# Americans with Disabilities Act (ADA) Self-Evaluation/Site Access Survey for the Town of Groton

Lost Lake Fire Station
Address: 185 Lost Lake Drive
Groton Fire Chief: Steele McCurdy
Tel: (978) 448-6333
Reviewed by the Commission on Accessibility
December 10, 2018

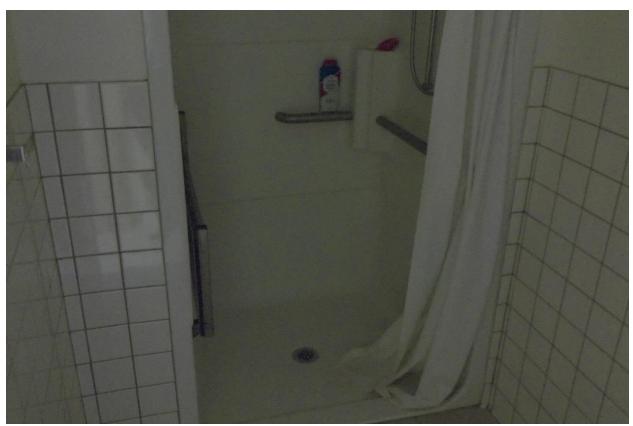
The ADA team found that there are cracks and weeds that have formed on the sidewalk that exceed ¾ inch. We recommend these be patched with fresh concrete with a suggested target date of December/2018.
